Re: Response to Traffic Peer Review Comments, 420 Harvard Street
Brookline, Massachusetts

Vanasse & Associates, Inc. (VAI) is pleased to submit responses to the September 22, 2016 Traffic Peer Review provided by Environmental Partners, Inc. These responses pertain to comments on crash data, mitigation, additional analyses, and design of the site driveway. For ease of reference, we have provided Environmental Partners' summary comments followed by our responses.

Figure 1: Eastbound Fuller Street Sight Distance of 418' to driveway.

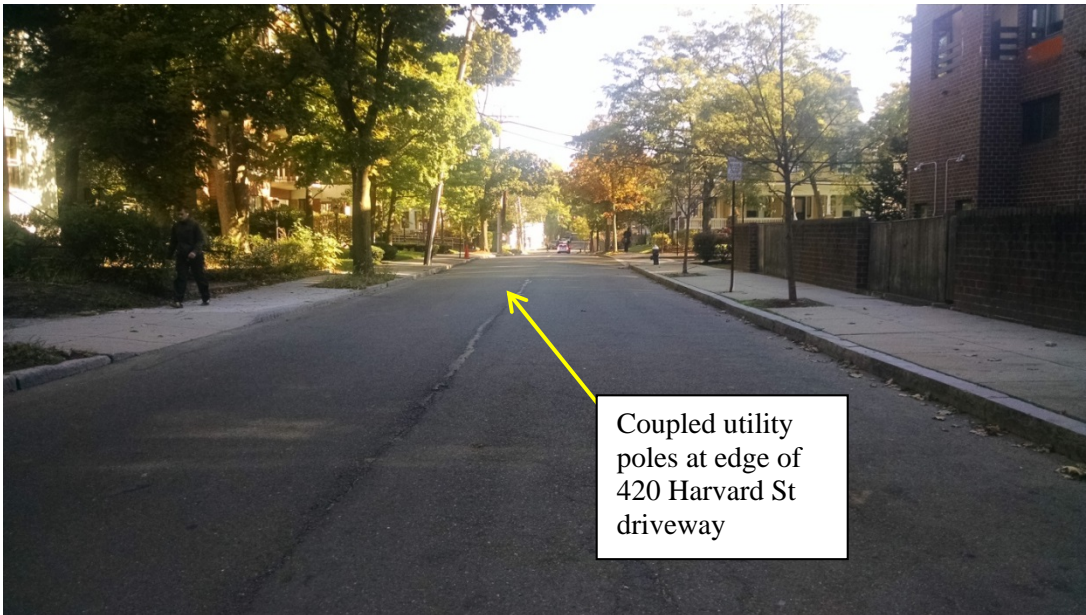
Comment 18: *“Sight distance from the proposed driveway will be limited by an existing 7 foot tall wooden fence along the southwestern property line that extends to the back of sidewalk. Due to the fence obstruction, sight distance for a vehicle stopped behind the sidewalk without protruding into the sidewalk is estimated at only 150 feet, which does not meet the 200 foot sight distance requirement for 30 mph.”*

Response: The 200 foot sight distance requirement for 30 mph referenced above is for Stopping Sight Distance (SSD), which measures the distance between the major road driver’s eye at a height of 3.5 feet and an obstruction in the road, representative of the height of

Based on AASHTO guidelines and the speeds shown in Table 3, the sight distance requirement for vehicles traveling on Fuller Street is approximately 120 feet for eastbound vehicles, and approximately 135 feet for westbound vehicles. Measurements conducted in the field indicate that a motorist traveling on Fuller Street either eastbound or westbound can see over 500 feet to the site driveway. Therefore, this requirement for safe SSD is met.

Another set of measurements was conducted at the request of the Peer Reviewer. This is the distance between a vehicle traveling eastbound on Fuller Street and an object representing a vehicle located at the back of the sidewalk, waiting to pull out from the driveway. This distance is shown below in Figure 1.

As shown in Figure 1 and measured in the field, a distance of 418 feet is available for motorists traveling eastbound on Fuller Street. This exceeds the SSD requirements identified by AASHTO for this criterion indicating safe sight distance is available. In addition, approximately 404 feet of sight distance is available from the proposed driveway location at the back of the sidewalk looking west up Fuller Street. This is shown in Figure 2.
